Access Compliance Report Public Rights-of-Way (Curb Ramps)

Main Street: ARROYO_AVE Cross Street: HYDE_PARK_DR Location: NW

ADA ID: RPRK211013113257 Ramp Type: Type 1 - Perpendicular Diagonal Initial Pass/Fail: Fail Overall Compliance: No Severity Score: 2

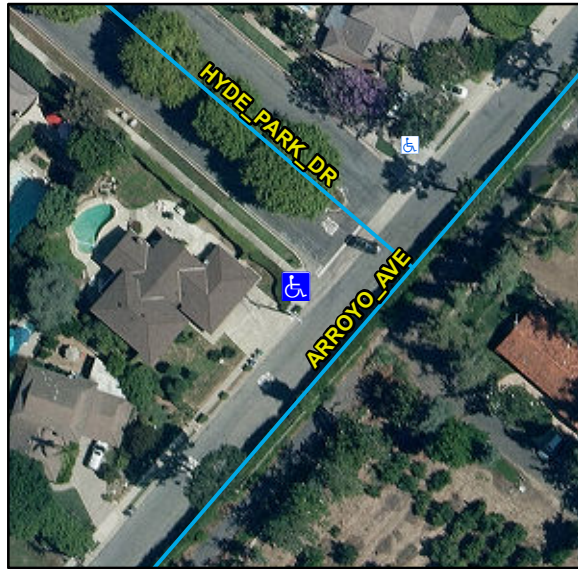
R304.5.3, STD 1115

Remove & Replace Curb Ramp With Two New Directional Ramps or Equivalent.
